Enter service bulletin number M1586 into Events Comments section of claim.

Figure 3. Straight End

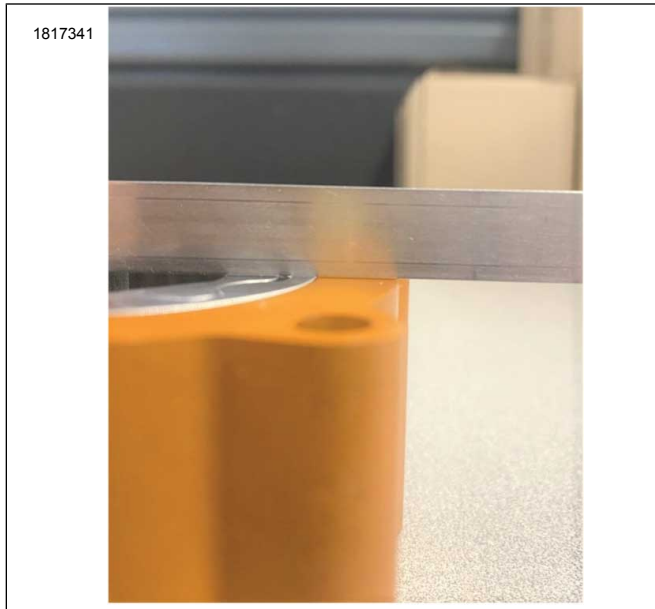
5. See Figure 3. For oil pumps with manufacturing dates in February 2023, lay a straight edge across the gerotors and the oil pump face.
 - a. If the gerotor faces are projecting slightly higher from face of the oil pump, then the pump is defective.
